BMS - 71 QUEBEC STREET  
3rd Floor  
June 04, 2015

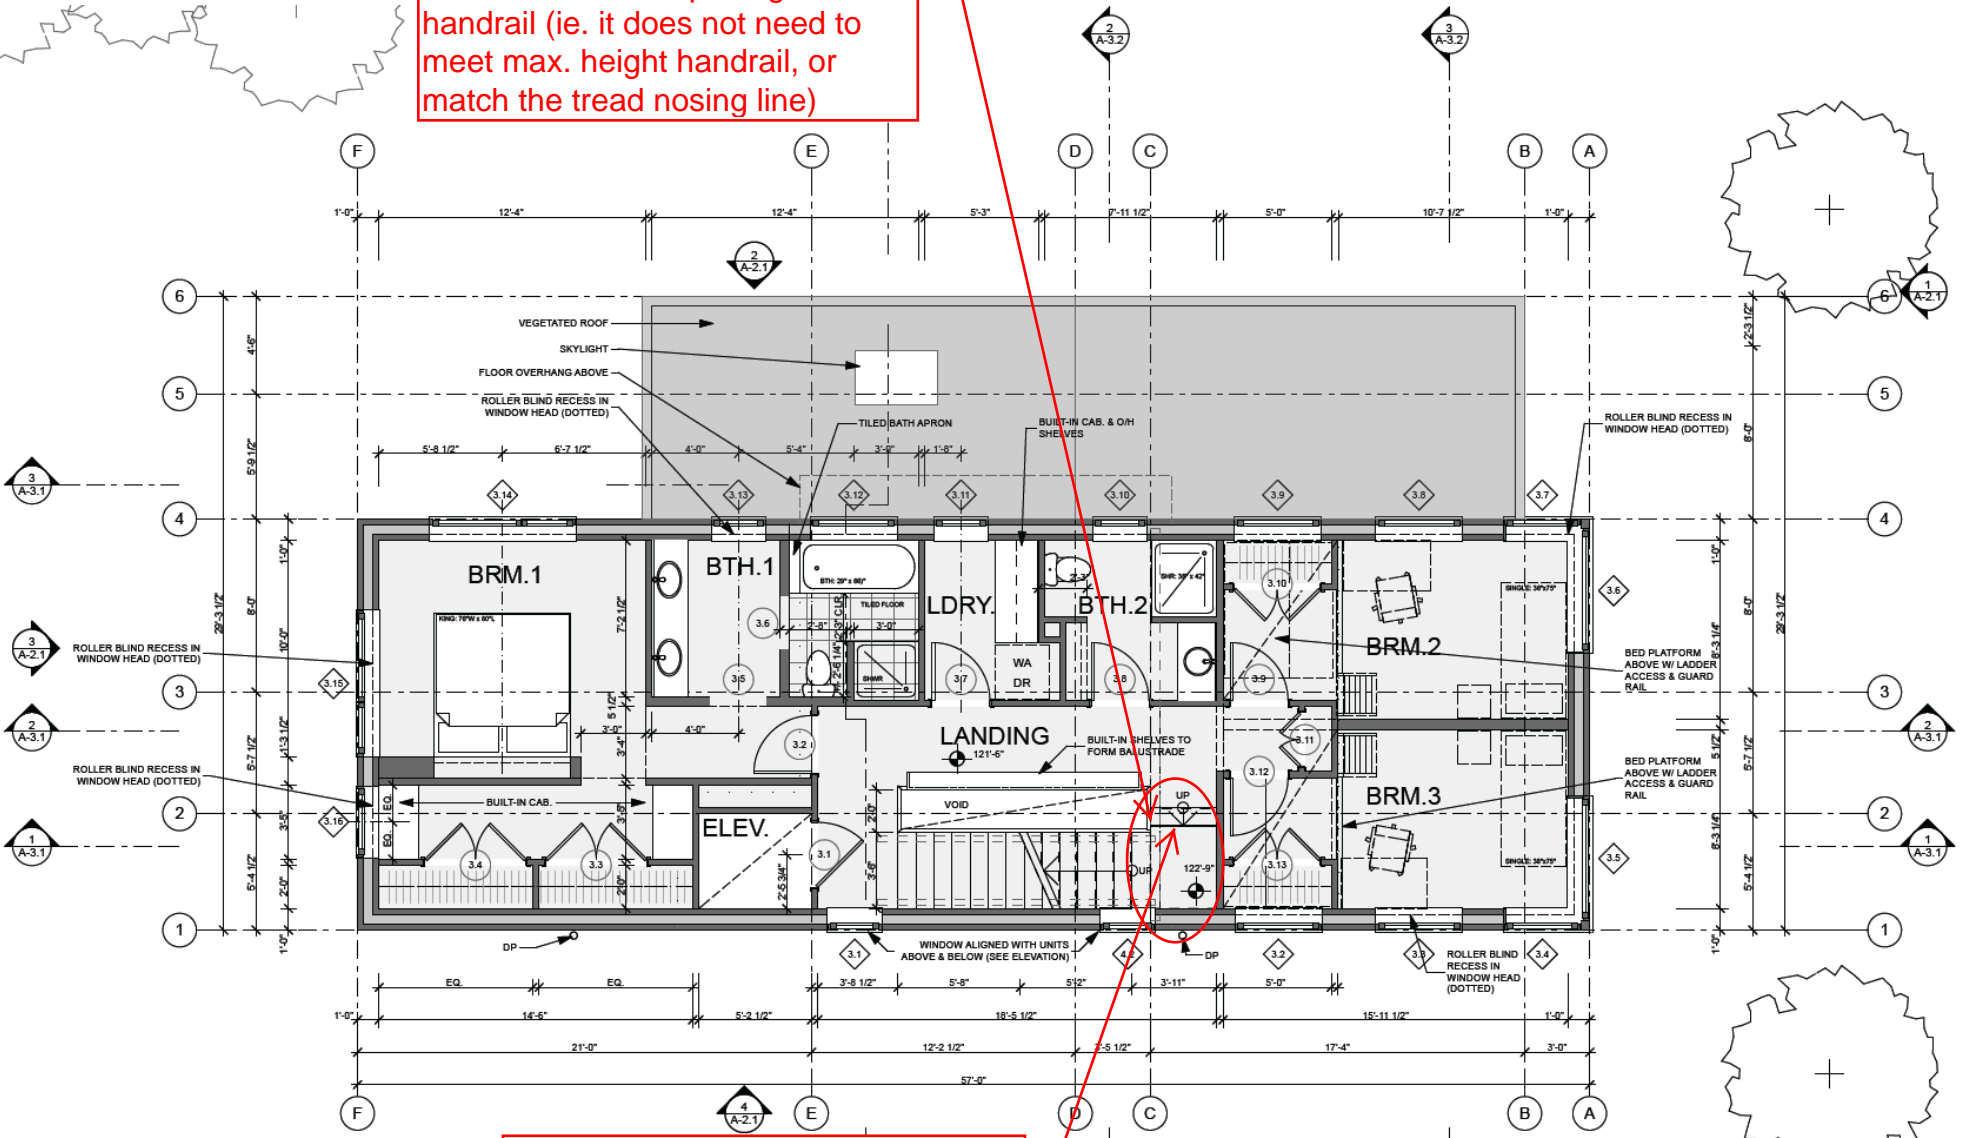
Top rail of balustrade guard at short end of floor opening is not a handrail (ie. it does not need to meet max. height handrail, or match the tread nosing line)

These 2 risers are considered elevations changes within the room per IBC-1009.12, exception 5
